**BEFORE THE MERIDIAN CITY COUNCIL**

**IN THE MATTER OF THE )  
REQUEST FOR FINAL PLAT )  
CONSISTING OF 8 BUILDING )  
LOTS AND 4 COMMON LOTS ON )  
4.82 ACRES OF LAND IN THE R-8 )  
ZONING DISTRICT FOR )  
WINDROW SUBDIVISION NO. 2. )  
)  
**BY: LAREN BAILEY )  
APPLICANT )**  
\_\_\_\_\_)  
)  
)  
)**

**CASE NO. FP-2026-0010  
ORDER OF CONDITIONAL  
APPROVAL OF FINAL PLAT**

**STAFF REPORT**  
**COMMUNITY DEVELOPMENT DEPARTMENT**

##### A. Preliminary Plat (dated: 9/13/23)

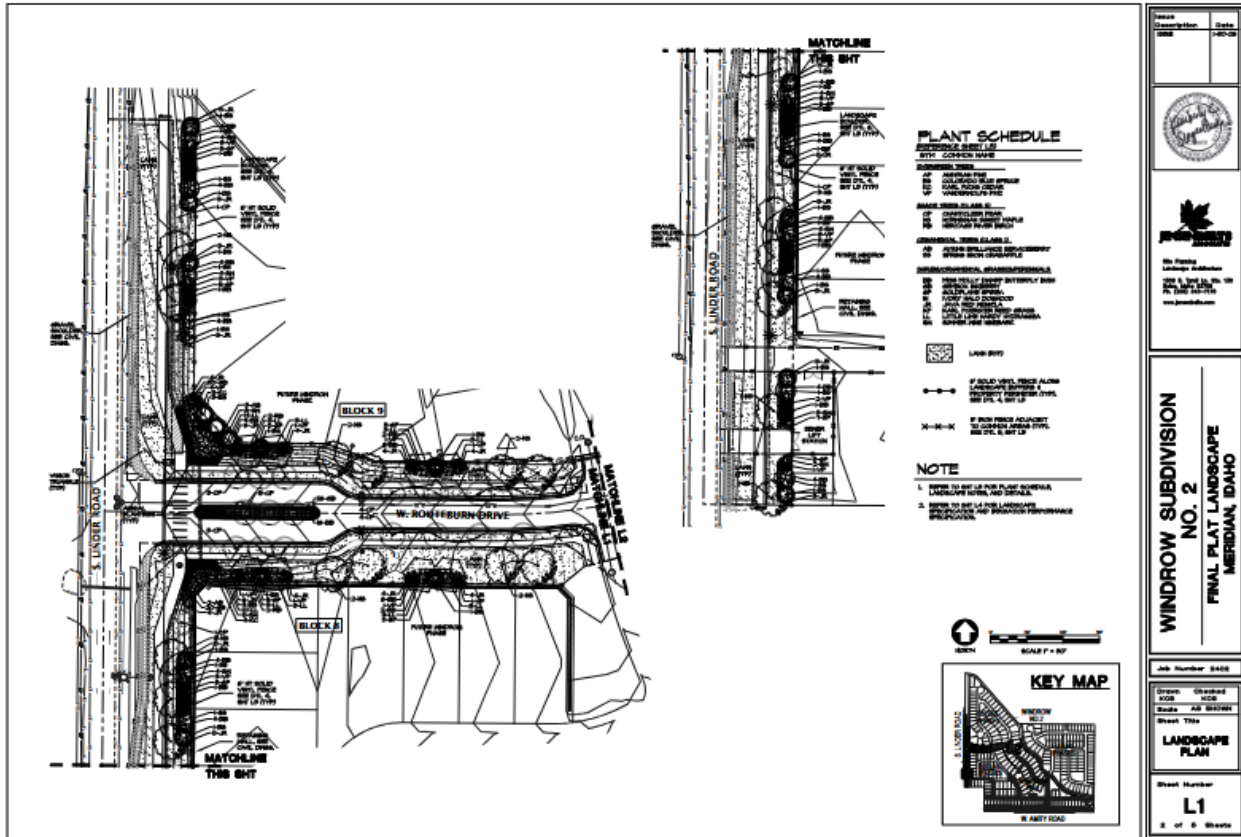
In order for the proposed final plat to be deemed in substantial compliance with the approved preliminary plat as set forth in UDC 11-6B-3C.2, the number of buildable lots cannot increase and the amount of common area cannot decrease. However, the road alignment and open space have changed

slightly from the preliminary plat. The applicants change in the phasing plan has accelerated the access point off of Linder Road to the second phase instead of the third. While this is a deviation from the approved phasing plan, staff has discussed with the applicant on the reasoning behind this change and it primarily due to market demands and having a second access point into the subdivision. Since there is no change to the number of buildable lots and the amount of common open space has increased slightly, therefore, Staff deems the proposed final plat to be in substantial compliance with the approved preliminary plat as required.

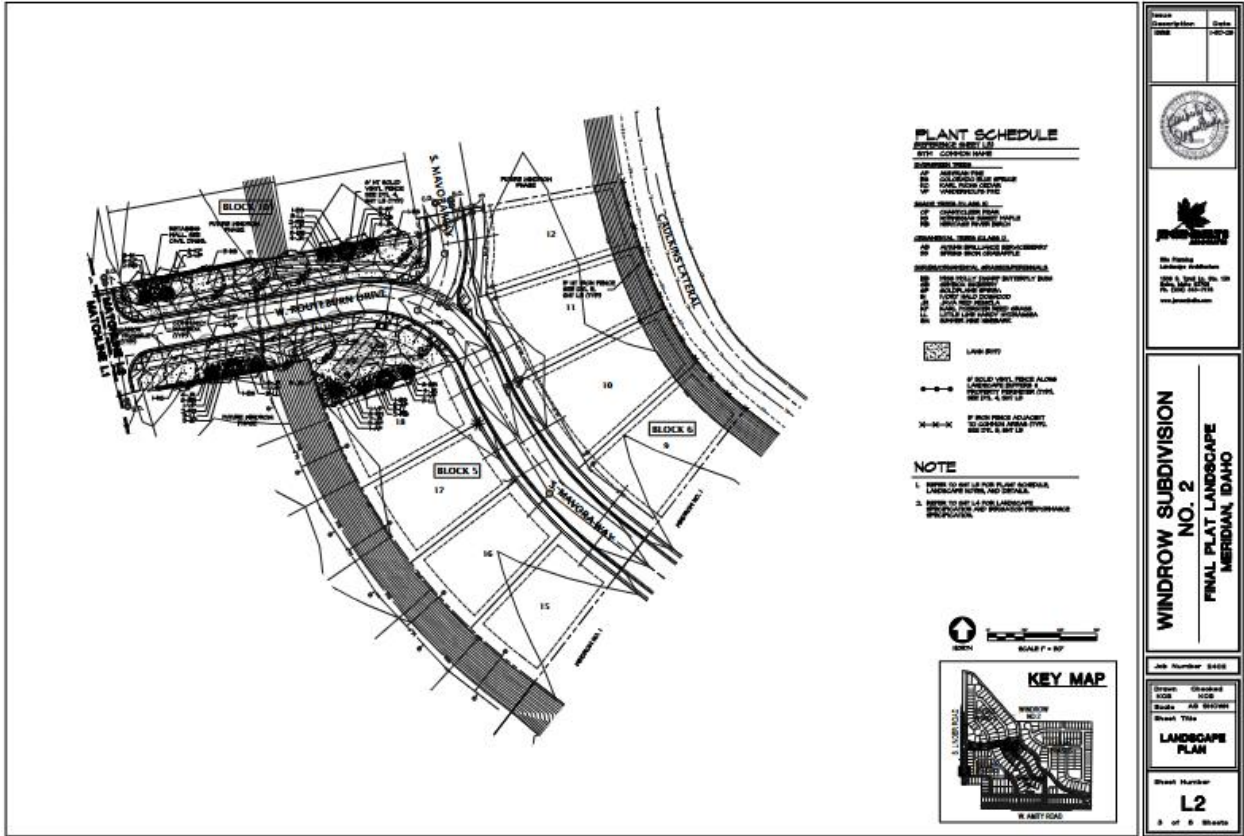
3. Prior to submittal for the City Engineer’s signature, have the Certificate of Owners and the accompanying acknowledgement signed and notarized.
4. The final plat prepared by Civil Site Works, dated: 11/2/2023, included in Section V.B shall be revised as follows:

- a. Note #6: Include the recorded instrument number for the ACHD license agreement.
  - b. Note #13: Include the recorded instrument number of the ACHD sidewalk easement.

- c. Note #14: Include the recorded instrument number of the City of Meridian Sanitary Sewer Easement.

- d. Note #16: Include the recorded instrument number of the City of Meridian Water Easement.  
*A copy of the revised plat shall be submitted with the final plat for City Engineer signature.*
